SUBJECT: PERRY NUCLEAR POWER PLANT, UNIT 1 - STAFF ASSESSMENT OF
FLOODING FOCUSED EVALUATION (EPID NO. L-2019-JLD-0020)

STAFF ASSESSMENT BY THE OFFICE OF NUCLEAR REACTOR REGULATION
RELATED TO THE FOCUSED EVALUATION FOR
PERRY NUCLEAR POWER PLANT, UNIT 1
AS A RESULT OF THE REEVALUATED FLOODING HAZARD NEAR-TERM TASK FORCE
RECOMMENDATION 2.1 - FLOODING
EPID NO. L-2019-JLD-0020

Figure 3.5-1 Locations of the annual inspection/maintenance performed at the North East bluff in the vicinity of the site. (Source: Perry FSAR Figure 2.4-32).

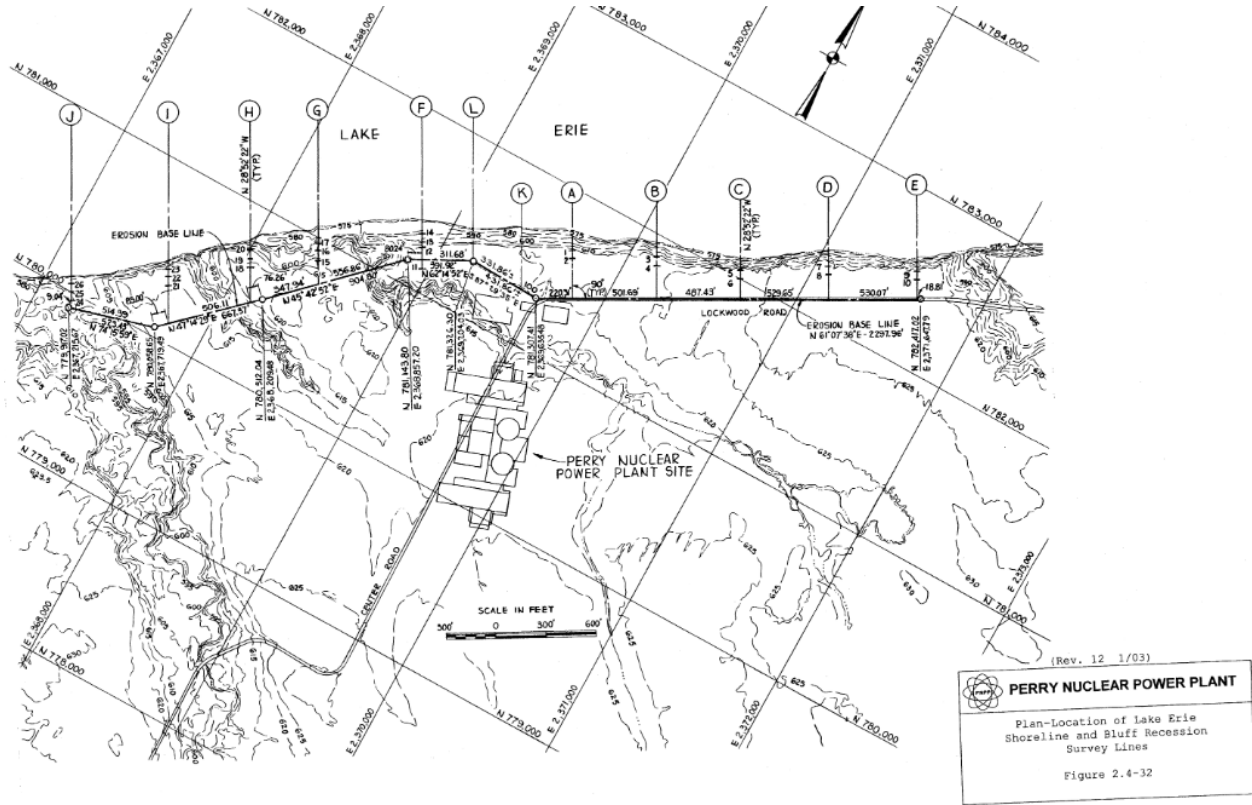
With regard to the inspection/maintenance performed in and around the bluff, the FSAR states that it is performed on an annual basis (spring) at several locations around the bluff. Figure 3.5-1 of this report shows the locations inspected. As part of the FE audit review (see additional details on Section 4 of this report), the NRC staff audited Perry procedure EMARP-0005, Revision 2, "Monitoring of Shoreline Recession and Bluff Erosion" which is part of the Perry Operations Manual. The NRC staff confirmed that proper procedures are in place, that clear guidance is provided to personnel responsible, and that remedial measures are unambiguously described such that any deterioration can be corrected and/or repaired in a timely manner. In addition, the procedure specifies the qualifications that personnel must have to conduct the inspection and scope of work to be performed. This determination by the NRC staff is consistent with the guidance described in NEI 16-05, Section B.2.1.1.

As a result of the above, the NRC agrees that an annual maintenance/inspection program should provide further assurance that the licensee will identify any potential signs of slope stability, seepage, erosion, and/or groundwater effects such that remedial actions can be undertaken.
